Re: **COMBINED FINAL WATER QUALITY
PLAN/SITE DEVELOPMENT STORMWATER
MANAGEMENT PLAN** for Ashford Woods
Preliminary Plan #: 120200110
SM File #: 285605
Tract Size/Zone: 141.4 acres/R-90
Total Concept Area: 101.4 acres
Lots/Block: N/A
Parcel(s): 787, 800
Watershed: Ten Mile Creek SPA

DRAINAGE AREA MAP

FINAL WATER QUALITY PLAN
ASHFORD WOODS
#120200110

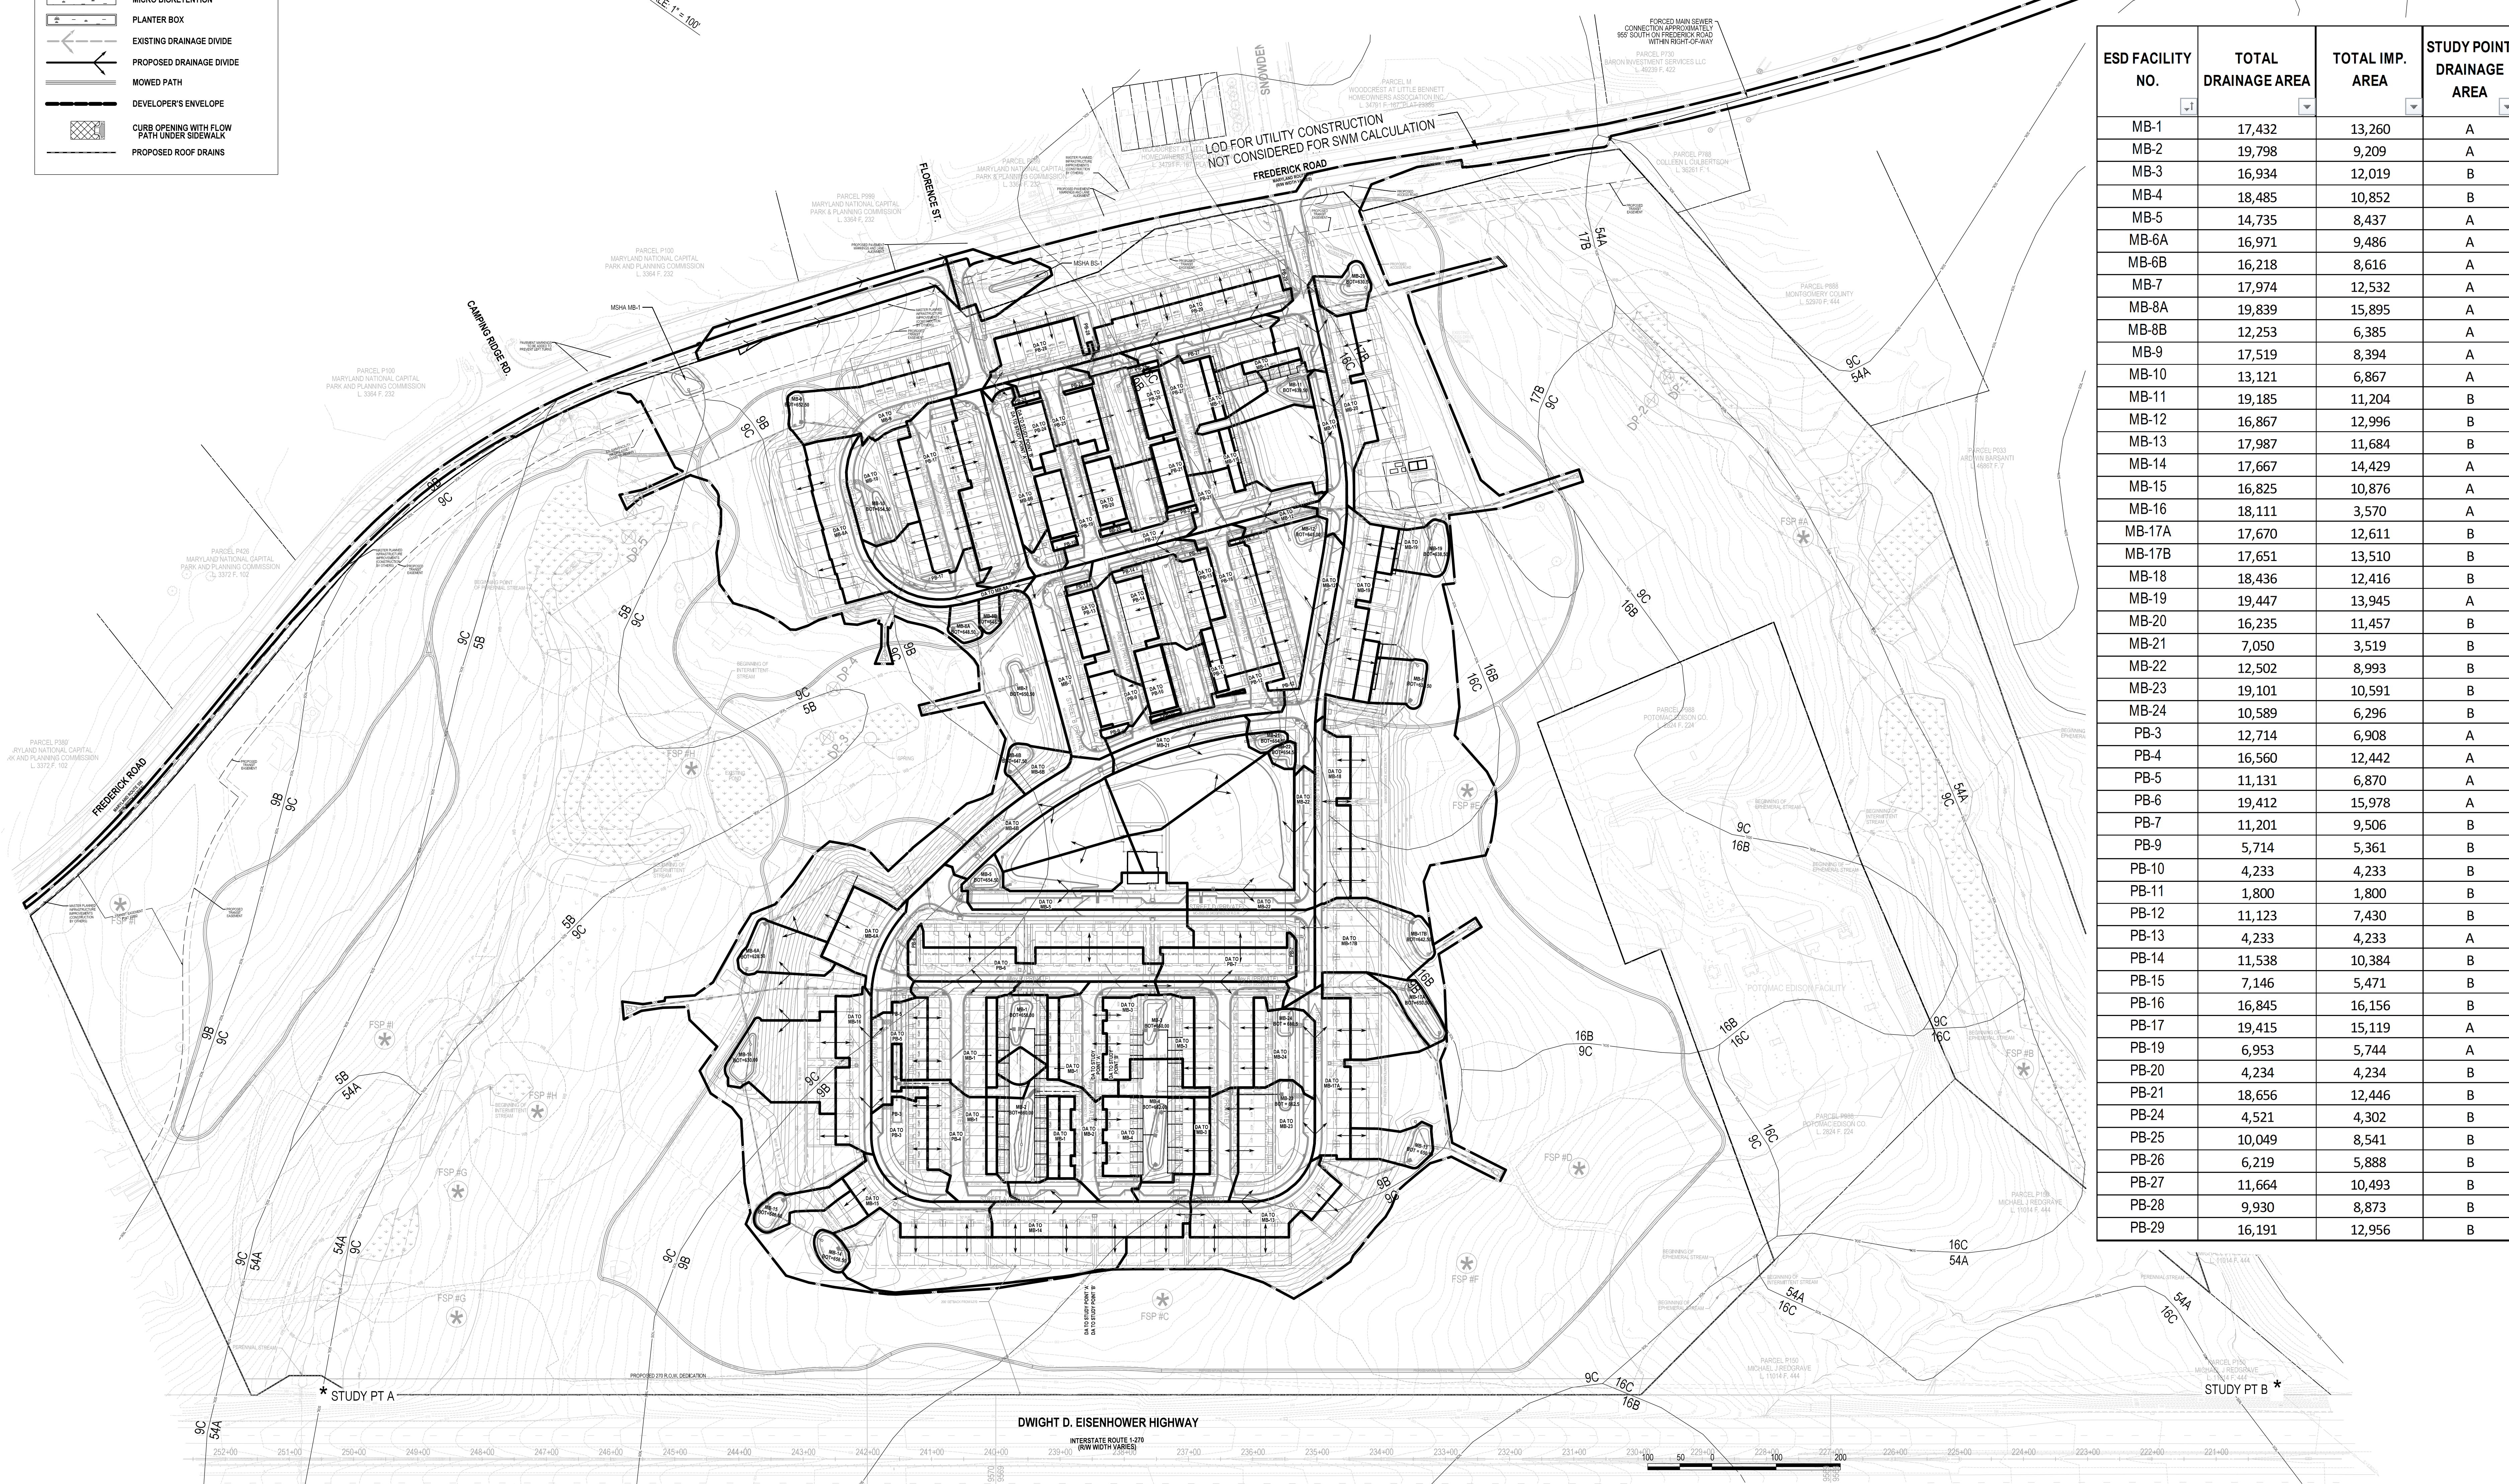
2. Outfalls must meet DPS standards for velocity and downstream conditions.
3. In some cases, micro bioretention structures are linked together. In these situations, all the structures need to have their own separate underdrains tying to the overflow structure.

4. Clearly demonstrate how runoff from the drainage area shown for micro bioretention structure #16 will get to the structure.
5. ESD needs to be provided for the proposed small parking area coming off Comus Road.

6. Enhanced soil preparation and topsoiling above and beyond the MDE requirements, must be provided for all disturbed areas more than 1,000 square feet. This will consist of soil loosening and fertilizing the top 6-8 inches of soil and providing a minimum 8-inch layer of topsoil. This will serve to promote infiltration and groundwater recharge.
